# Access Compliance Report

## Public Rights-of-Way

### (Curb Ramps)

Intersection ID: 43979	Main Street: SHARON_VIEW_RD	Cross Street: PARK_PHILLIPS_CT	Location: NE
ADA ID: ABE13C7D0FB4	Ramp Type: BlendTrans2	Initial Pass/Fail: Fail	Overall Compliance: No
Severity Score: 1.25			
Codes/Mitigation Info/Possible Solution		Field Measurements/Component Compliance

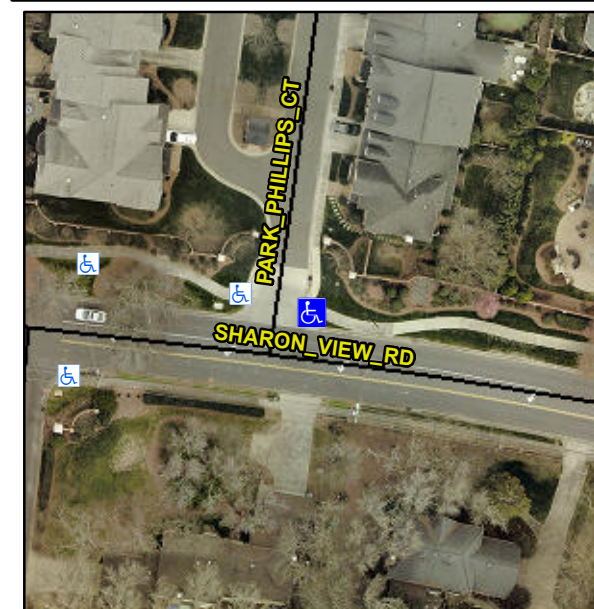
**Remove & Replace Curb Ramp With Two New Directional Ramps or Equivalent.**

**R304.5.3**
